Roundabout Traffic & Safety Assessment and Functional Design Review

Airport Road Environmental Assessment, King Street to
Huntsmill Drive

Prepared for Region of Peel
by IBI Group
August 9, 2019

A *Roundabout Functional Design Review – 1st Review draft* was completed on September 18, 2018 by John Bayley, P.Eng and Mr. Sergei Filippov, C.E.T. The design review provided observations, suggestions and comments on the functional aspects of each of the three roundabouts with inputs later incorporated into the designs, dated October 12 (refer to Exhibit 3-3, Exhibit 4-3, and Exhibit 5-3). Following the first review, *Roundabout Functional Design*

FIGURE 1A

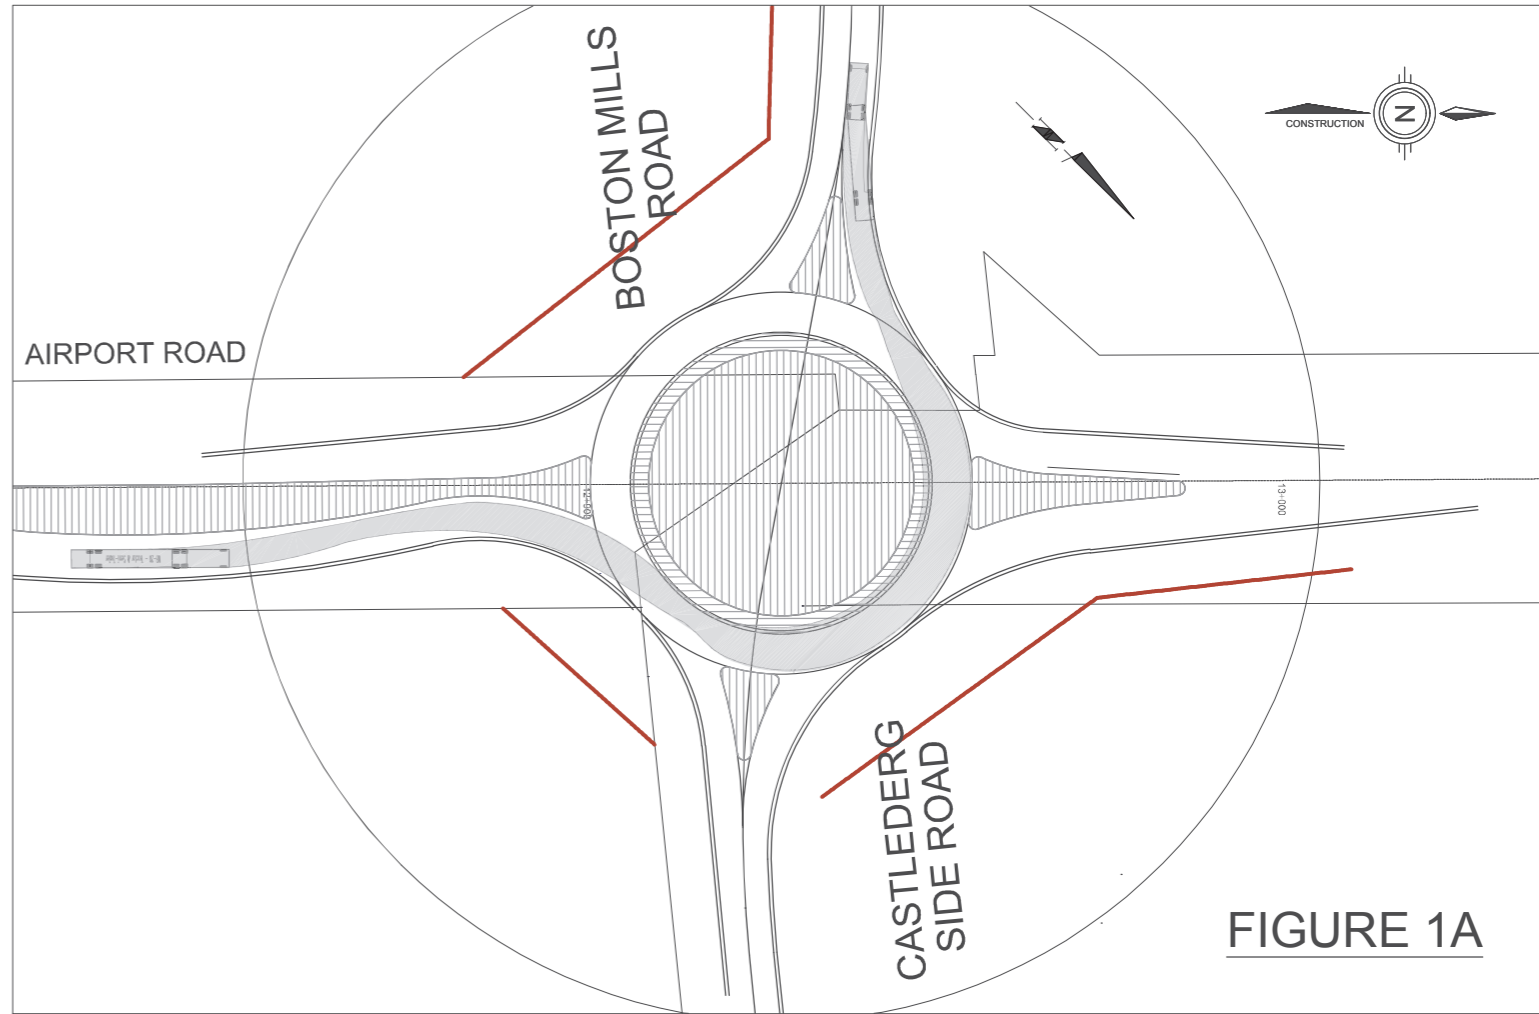
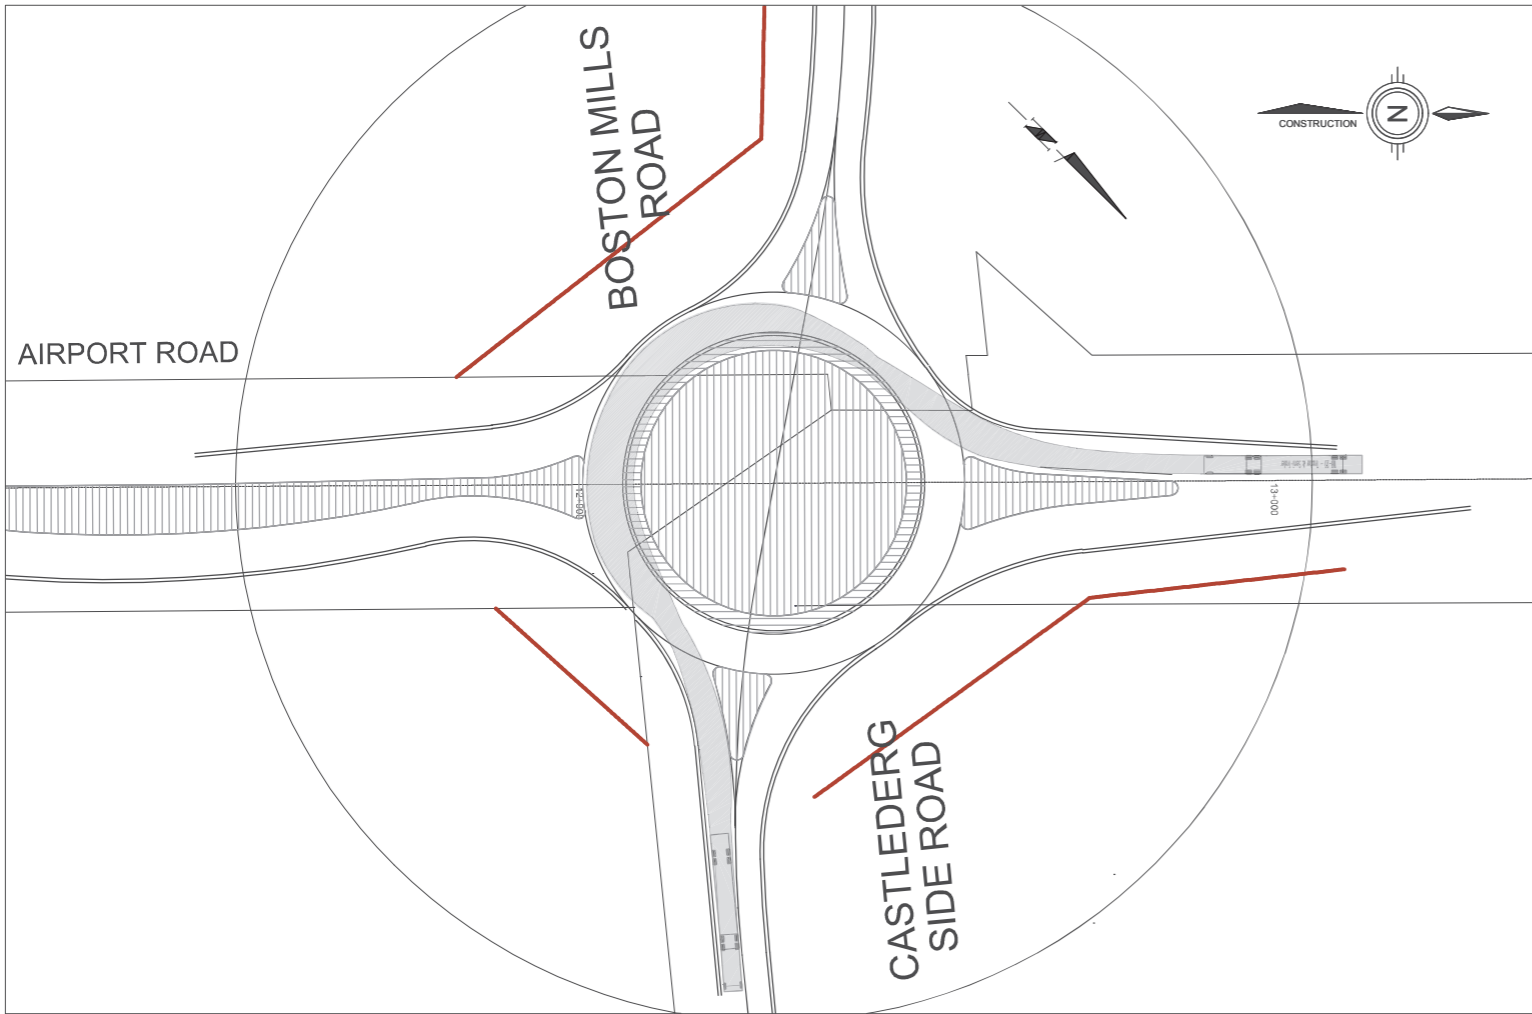
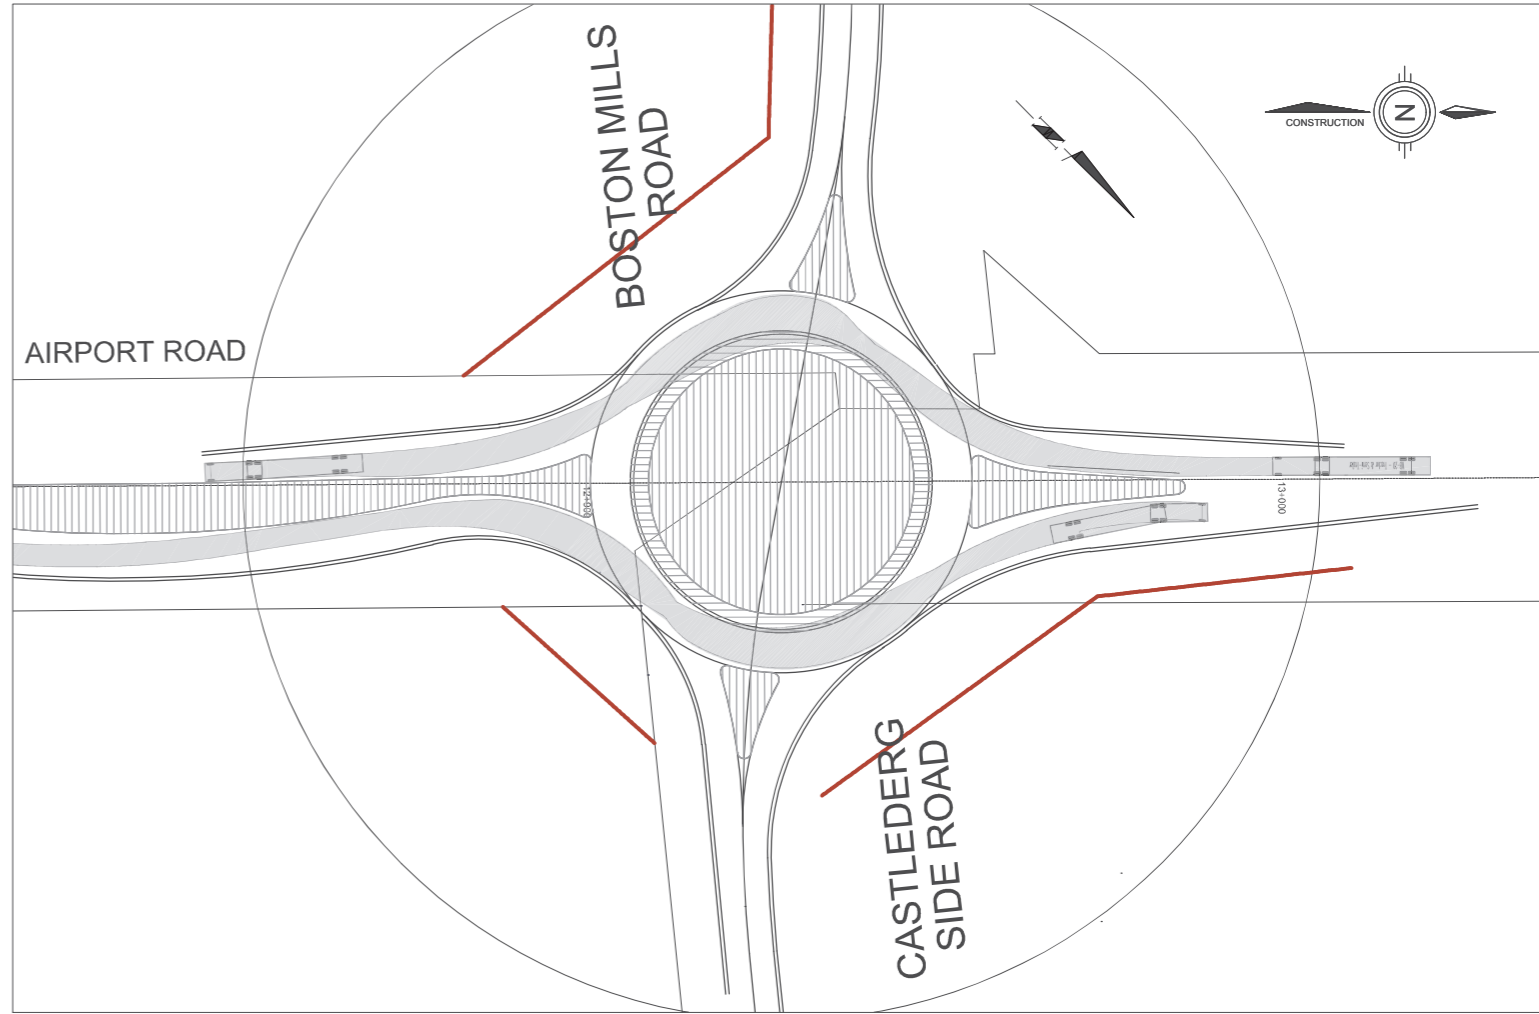
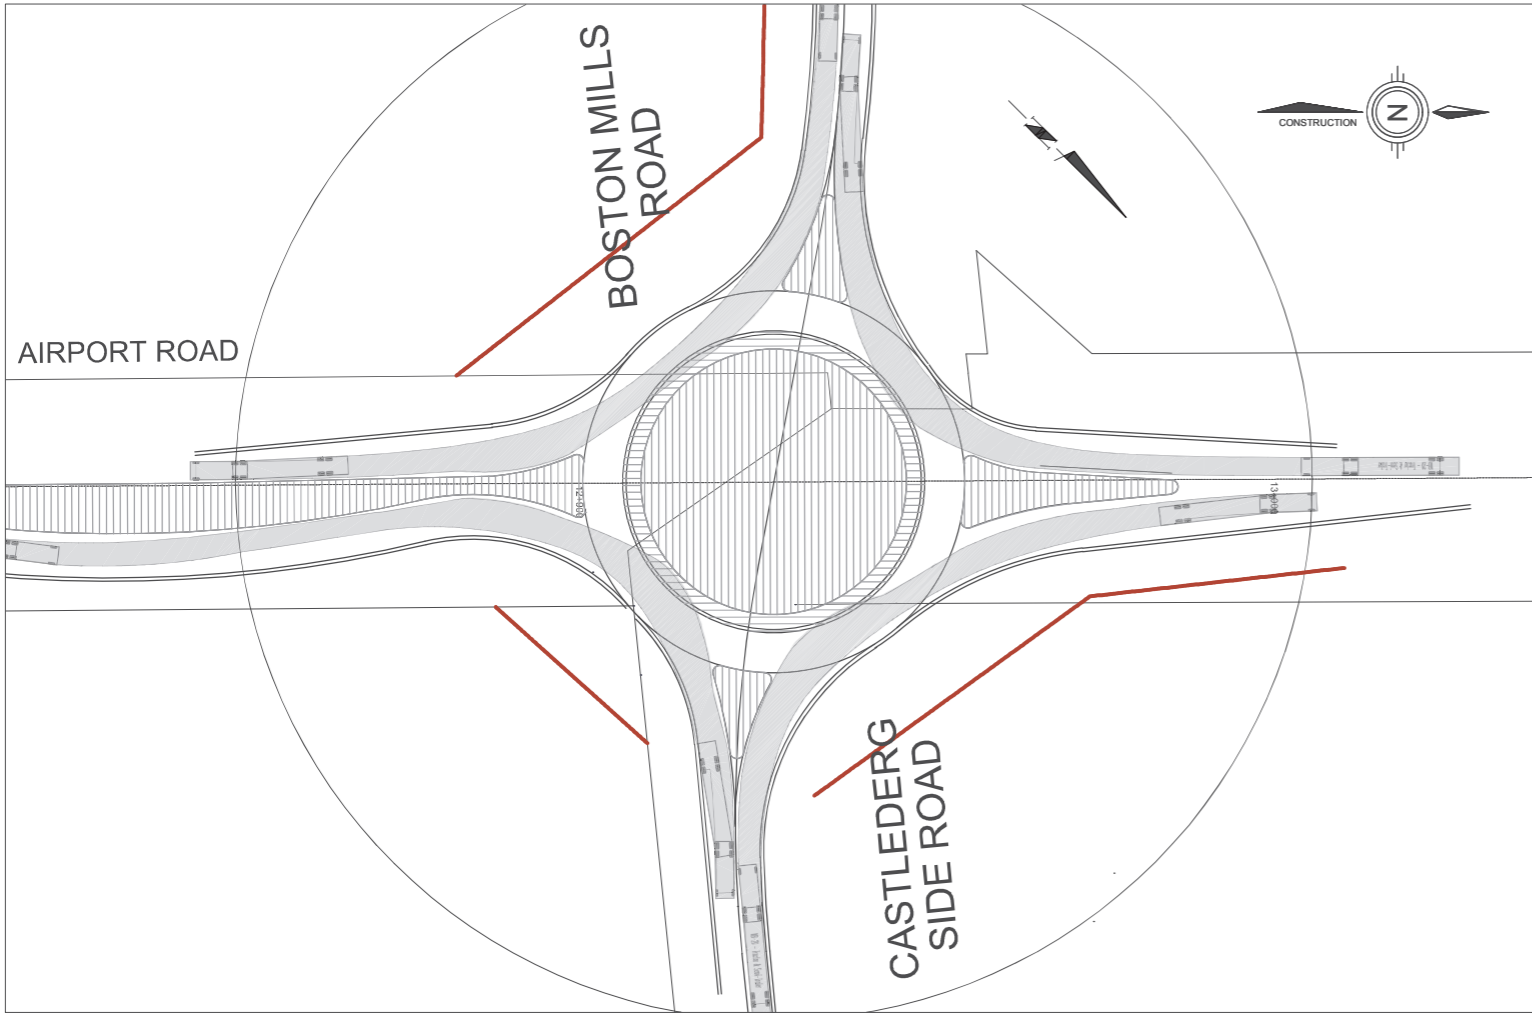
Swept Path Analysis: Preliminary review – WB-20 design vehicle – see attached Figure 1A

Truck Turning – See Swept Path analyses in Figure 1A. West and East legs appears to be too narrow to accommodate WB-20 truck movements. The study report confirms that Airport Road is a designated truck route and as such the safe movement of goods is a study goal.
